TRANSMITTAL OF PROPOSED CHANGES  
TO GRAND GU/F TECHNICAL SPECIFICATIONS

1. (GGNS - 16)

SUBJECT: Technical Specification Table 3.3.3-2, page 3/4 3-29.

Figure 1

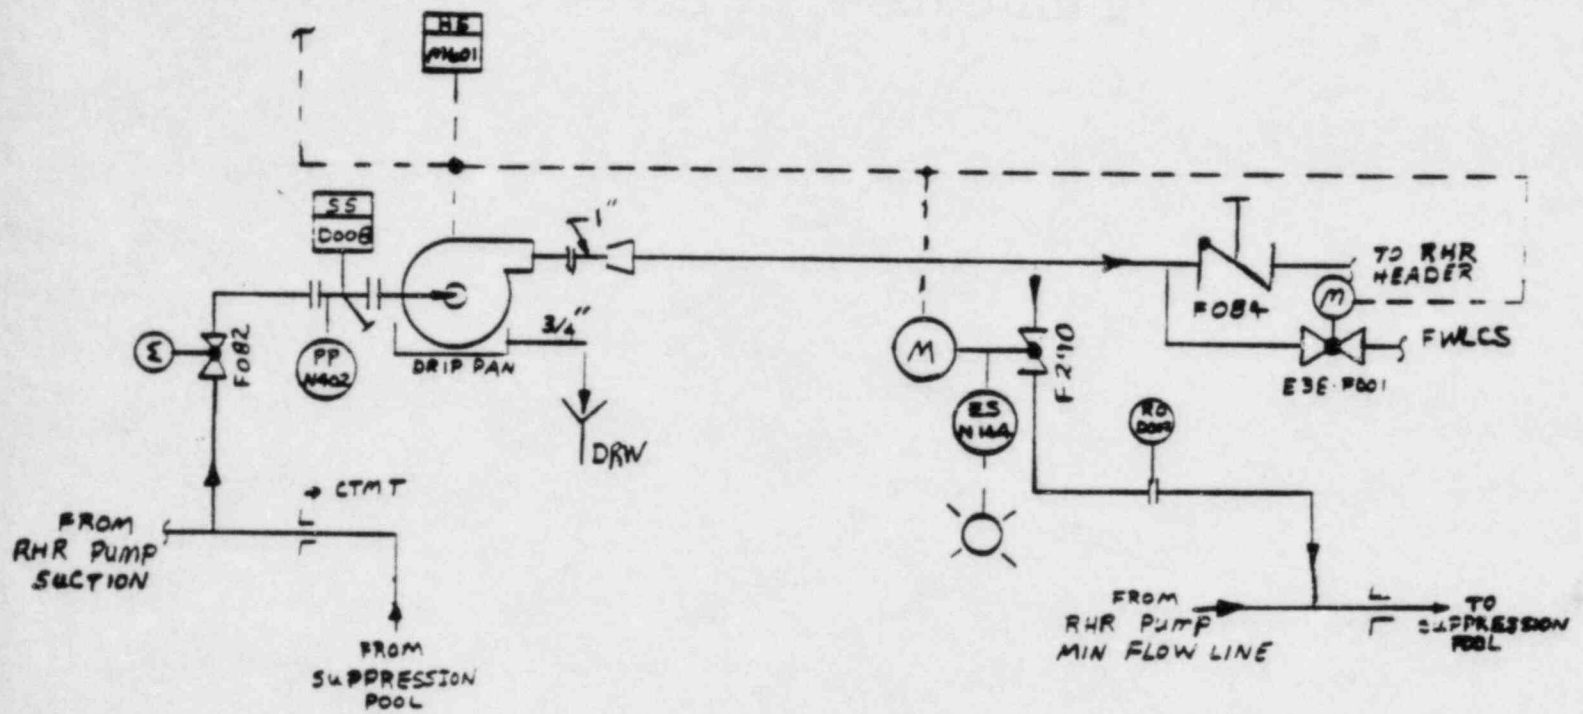
A simplified sketch of the jockey pump subsystem arrangement is provided in Figure 1 of this attachment. During normal operation, the FWLC supply valves are closed and the minimum flow valves are open to allow the jockey pumps to supply pressurized water to the RHR pumps and discharge piping. The minimum flow valves were provided with a containment isolation signal since the jockey pump discharge returns to a point downstream of the isolation valves (E12-F064A&B) in the RHR test return line.

#### IV. Description of Proposed Design Change

The proposed design change to correct the described deficiency will revise the logic for both the jockey pumps and their associated minimum flow valves. The principal changes are described as follows:

Implementation of the proposed design change package described above will correct the identified deficiency and assure that a pressurized source of water is provided to the RHR pump and discharge piping continuously.
